App. No. 10/724,436  
Amendment dated 02/17/2005  
Reply to Office Action of 11/17/2004

**AMENDMENTS TO THE DRAWINGS**

In re: Martin et al. Serial No. 10/724,436  
For: BRAZED SHEETS WITH ALIGNED  
OPENINGS AND HEAT EXCHANGER FORMED  
THEREFROM

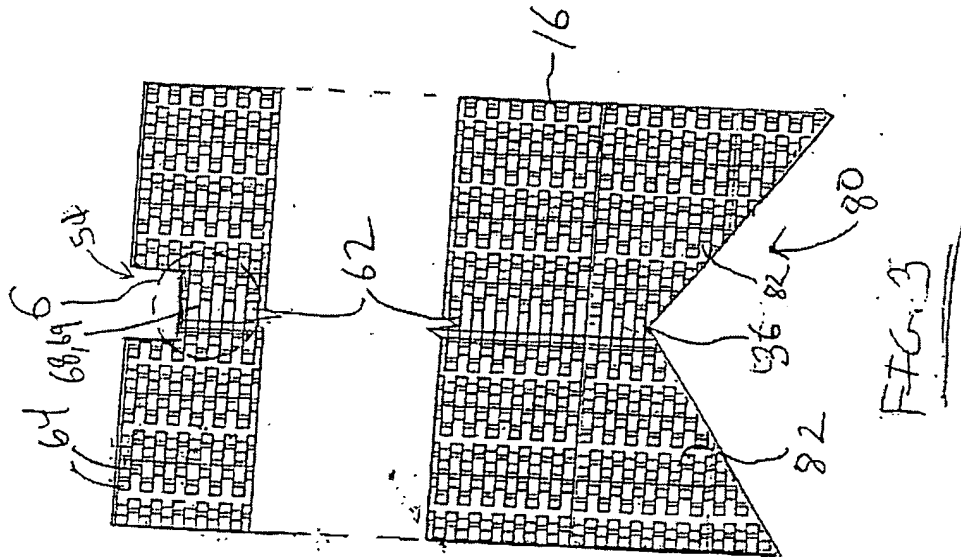
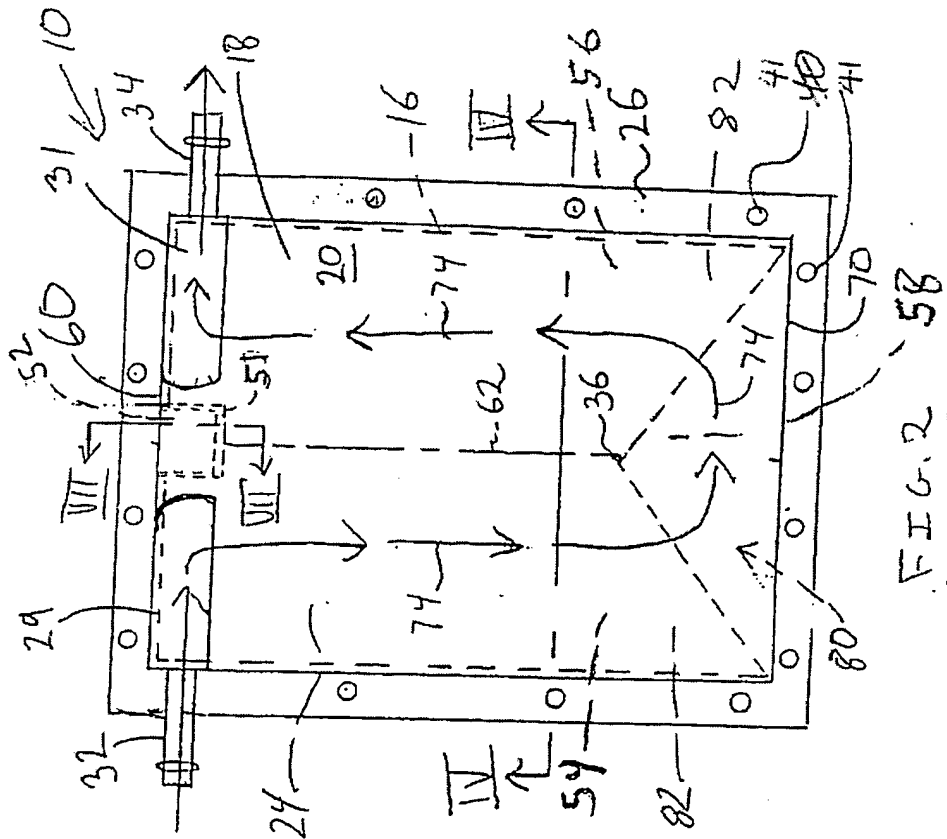
In addition, some minor corrections have been made to Figures 1, 2, 5, 13 and Figures 14A to 14D and sheets of the original drawings containing these figures are enclosed in the Appendix. These sheets are marked as "ANNOTATED" to indicate the amendment made in the formal drawings.

In particular, the reference number 40 used to identify the fastener holes in the cover plate has been replaced by number -- 41 -- while the reference numbers "42" used to indicate the fastener holes in the plate 14 have been changed to -- 43 --. These changes were necessary in order to avoid the use of the same reference number to identify different features.
